**APPLICATION AND
PRELIMINARY PLAT CHECKLIST**

THE SHORES-PHASE THREE
NATHAN BUTLER SURVEY ~ ABSTRACT NO. 21
THOMAS DEAN SURVEY ~ ABSTRACT NO. 69
CITY OF ROCKWALL, ROCKWALL COUNTY, TEXAS
Shores Country Club, Inc. (Jeff Barnes-Tel. No. 238-0401)-Owner
111 West Spring Valley Road - Richardson, Texas 75083-0160

HAROLD L. EVANS CONSULTING ENGINEER 2331 GUS THOMASSON RD., SUITE 102 DALLAS, TEXAS 75228 PHONE (214) 328-8133			THE SHORES - PHASE FOUR THOMAS DEAN SURVEY ~ ABSTRACT NO. 69 SAMUEL KING SURVEY ~ ABSTRACT NO. 131 CITY OF ROCKWALL, ROCKWALL COUNTY, TEXAS Shores Country Club, Inc. ~ Owner ~ Jeff Barnes Tel. No. 214-738-0401 111 West Spring Valley Road - Richardson, Texas 75083-0160		
SCALE	DATE	JOB NO.	SCALE	DATE	JOB NO.
1"=100'	7-19-90	9089

I have reviewed the preliminary plats for Phase 3 and 4 of the Shores. I have the following comments regarding the plans:

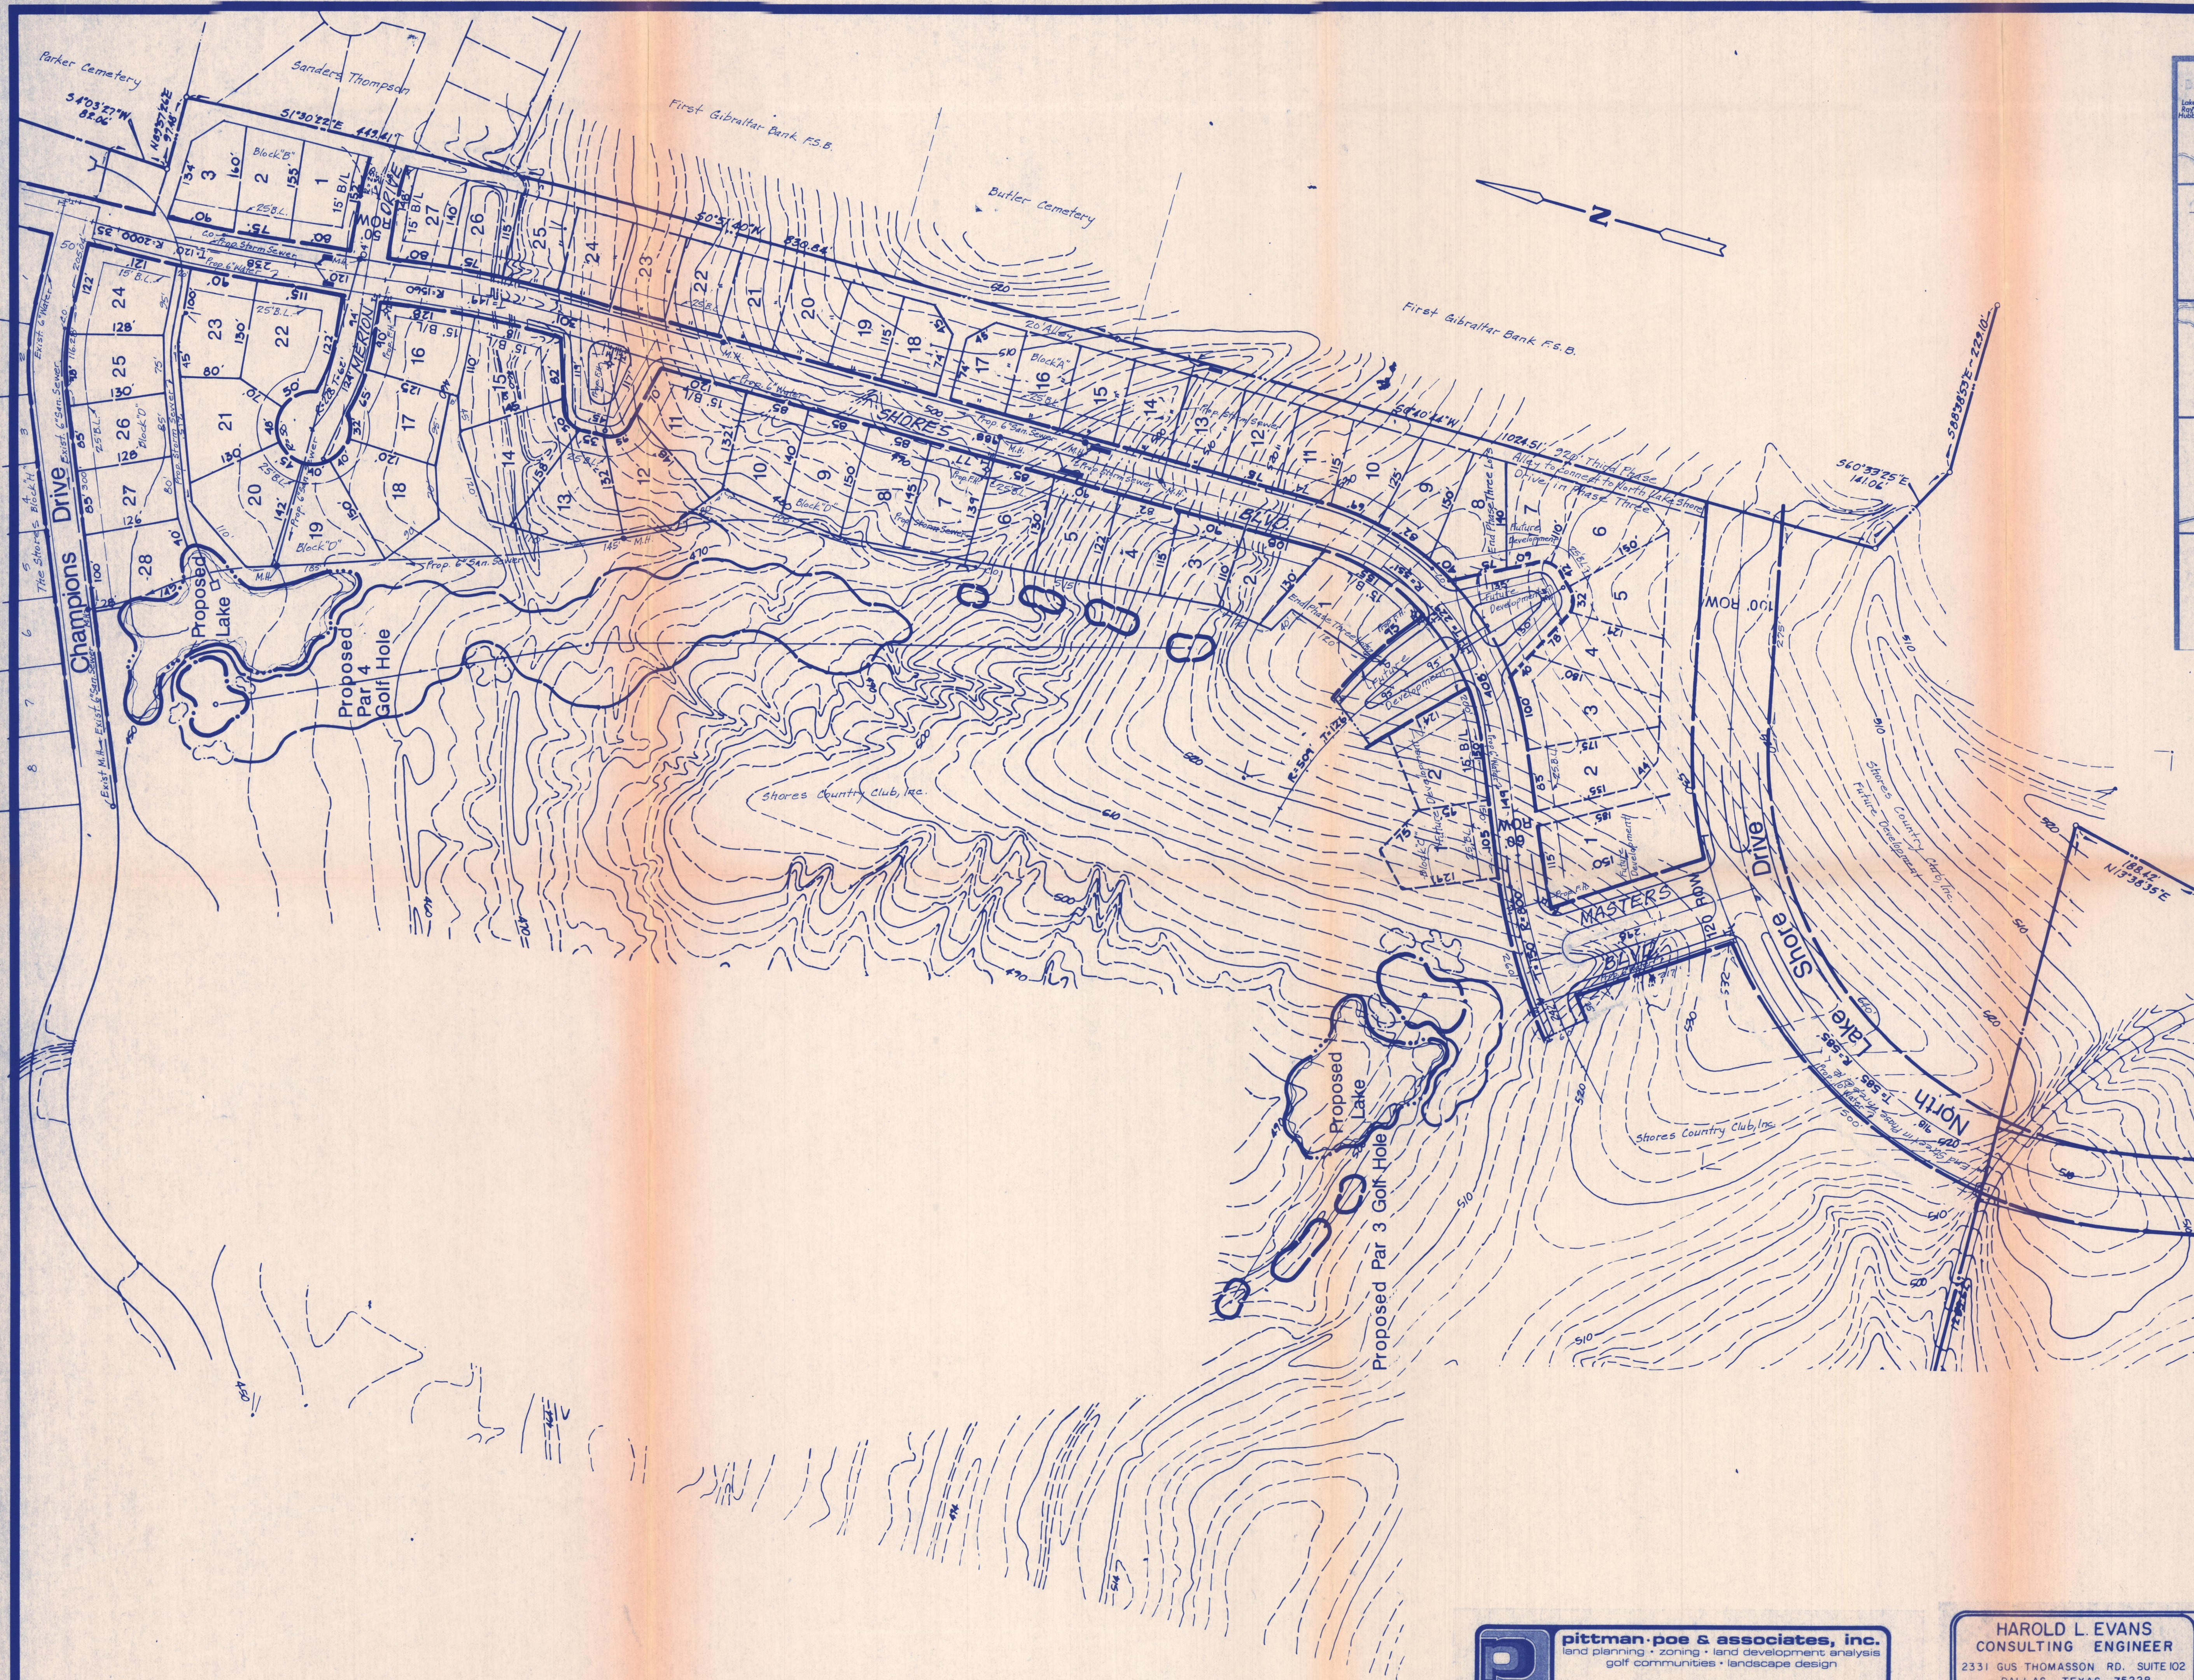
Phase 3

1. The lots facing the future street toward the golf course need to have 25' side setbacks because they will rear up the side of the adjacent lots. Lot 1 off of this street should not be built unless you are ready to construct the street to access it.
2. Any proposed median improvements for the drive off of N. Lakeshore will need to be approved by the City. We will ultimately need a plan for this area.

3. Is there a concept of how the lots will be designed off of the future street toward the golf course. This would be helpful to see how it may develop ultimately in this area.
4. As you are aware, it is my understanding that the old 16" water line will need to be activated with this phase. You will need to talk to Dub about this in more detail.
5. Will part of the golf course be included in this plat?
6. You need to ensure that all of the lots meet the minimum size requirements as provided in the preliminary plan. It is likely that the Commission and Council will restrict those lots that face Champions Drive so that garages will not face the street.

1. The lots facing the future street toward the golf course need to have 25' side setbacks. Lot 1 off of this street should not be built until the street is built.

2. Any proposed median improvement for the drive off of N. Lakeshore will need to be approved by the City.
3. The lots facing Champion Drive should be required to have garages that do not face the street just as the other houses along Champion.

4. The developer is proposing to shift the alignment of N. Lakeshore northward to utilize the existing ROW for Lakeshore on the Gibraltar property. The developer has been unable to gain agreement from the RTC, who is now in charge of the Gibraltar property, to give the new ROW in return for the old ROW. While the proposed alignment will work, it does move the 4 lane road north of the old site and away from the commercial tract as shown on the drawing. This may result is a request in the future for a change in zoning on thes other parcels and the Commission and Council need to b4e aware of that.

5. The developer is requesting that no alleys be required behind the lots adjacent to the golf course. This was approved on the lots that were approved in the old Phase 3.

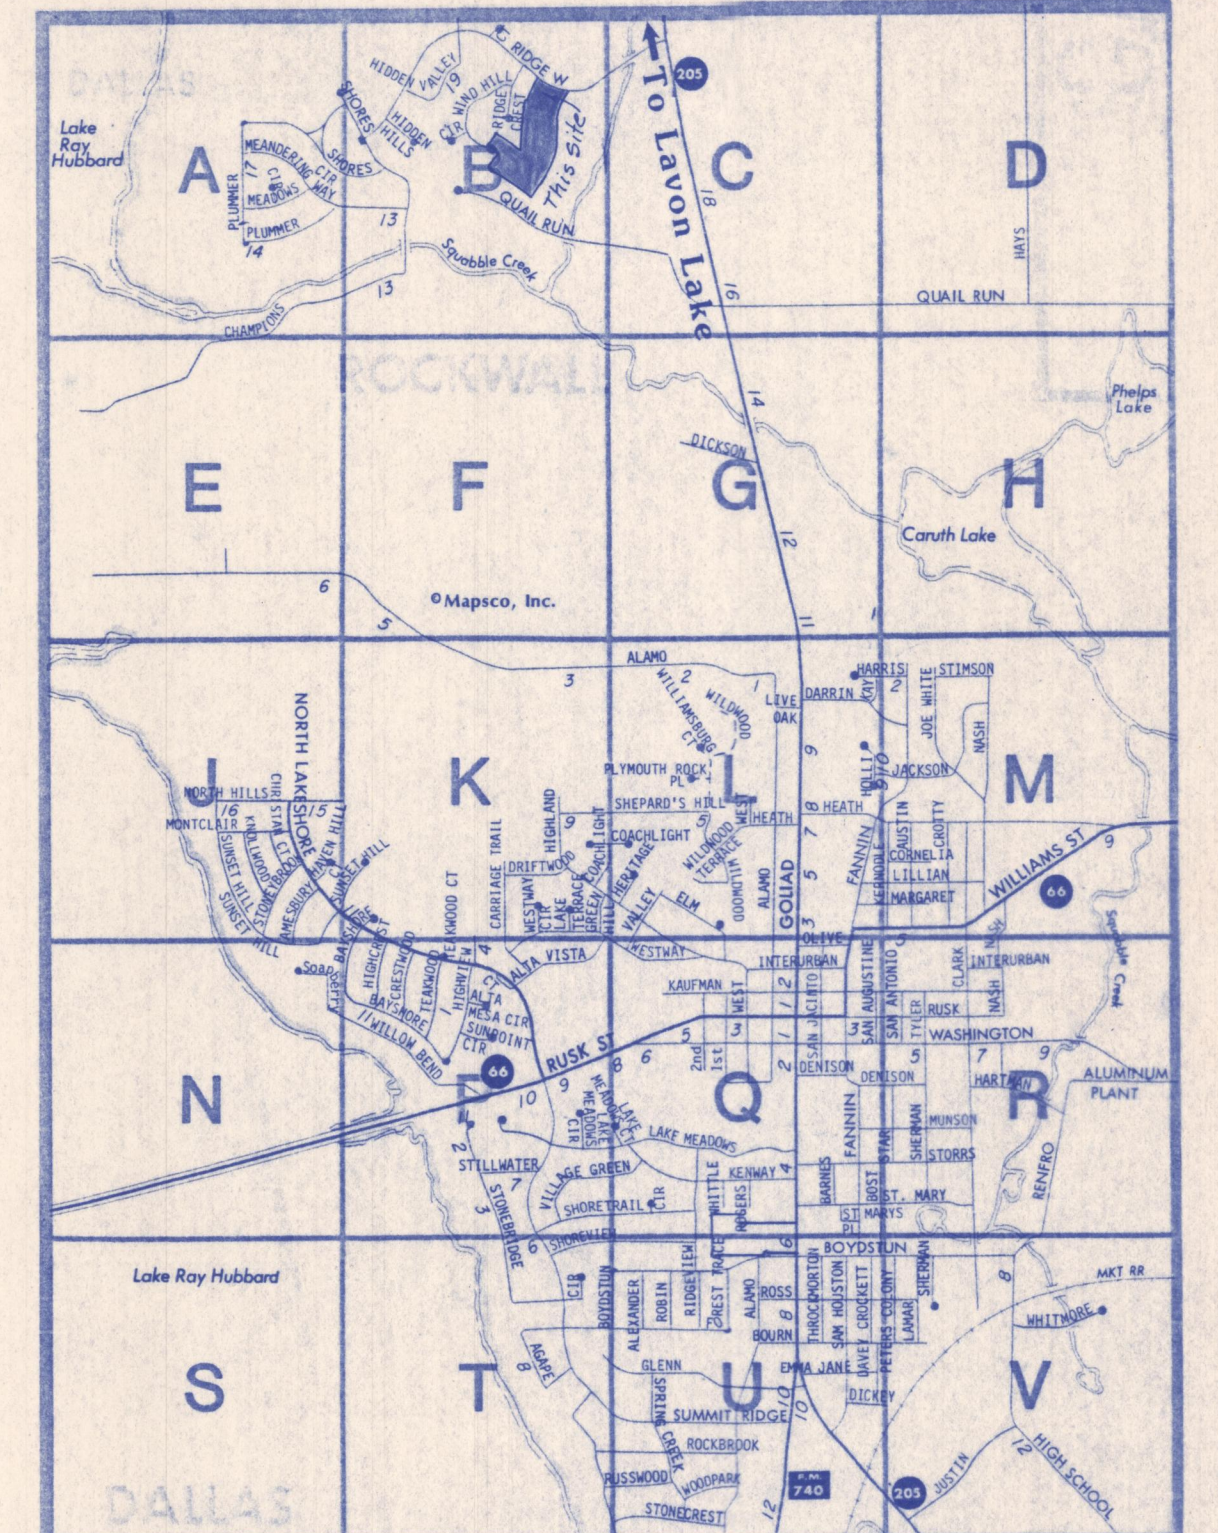
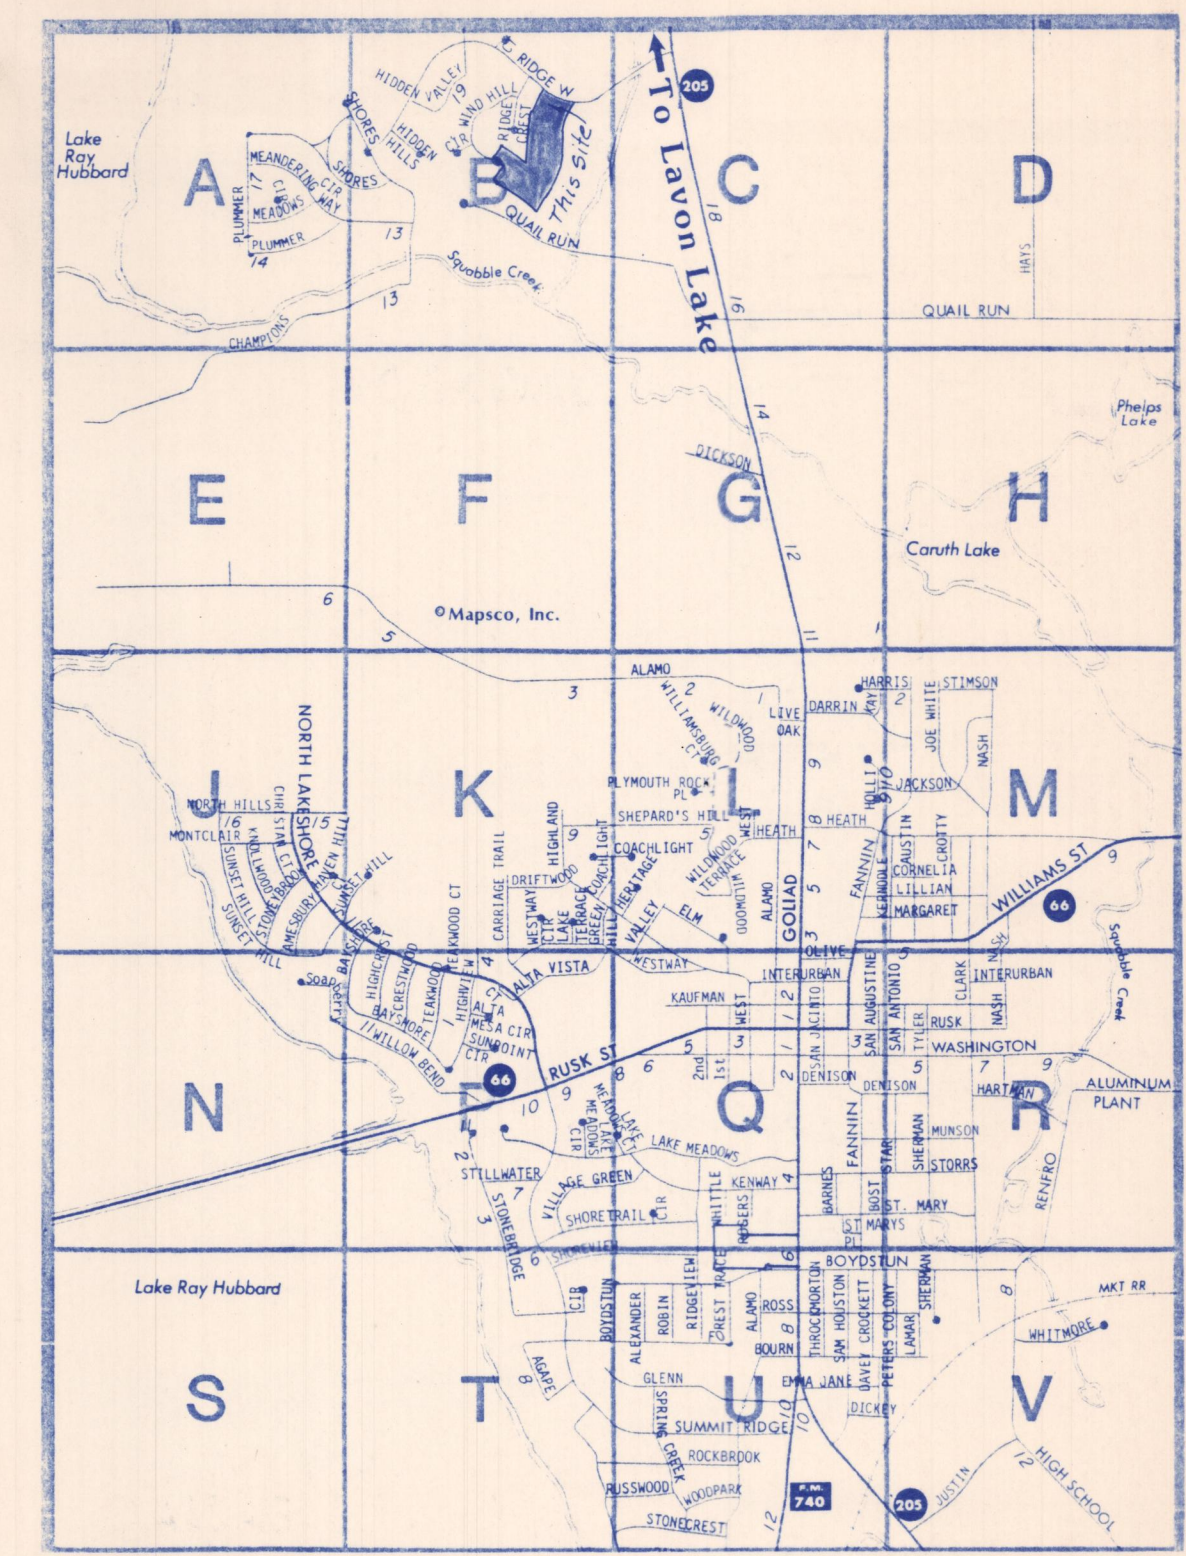
Phase 4

1. As you are aware the property frontage along Quail Run Road is considered frontage on a substandard Road and our Subdivision policies require that the ROW be dedicated and that either 1/2 of the road be improved along the frontage or the funds necessary for the improvement of that frontage be escrowed with the City. In this case it would not be appropriate to improve that small portion of Quail Run so the funds would need to be escrowed with the City.
2. We need to look at some through alley access from Wind Hill Road to Quail Run Road.
3. You need to ensure that all lots meet the minimum size requirements as provided in the Preliminary Plan.
4. Dub has received a copy of the plat and he will need some additional information regarding utilities and storm drainage.

1. There should be some alley connection to Quail Run Road from this addition.
2. The property frontage along Quail Run Road is considered frontage on a substandard Road and our Subdivision policies require that the ROW be dedicated and that either 1/2 of the road be improved along the frontage or the funds necessary for the improvement of that frontage be escrowed with the City. In this case it would not be appropriate to improve that small portion of Quail Run so the funds would need to be escrowed with the City.

1. There should be an alley connection to Quail Run Road from this addition. The developer has revised the preliminary plat to include this alley connection.
2. The property frontage along Quail Run Road is considered frontage on a substandard Road and our Subdivision policies require that the ROW be dedicated and that either 1/2 of the road be improved along the frontage or the funds necessary for the improvement of that frontage be escrowed with the City. In this case it would not be appropriate to improve that small portion of Quail Run so the funds would need to be escrowed with the City.
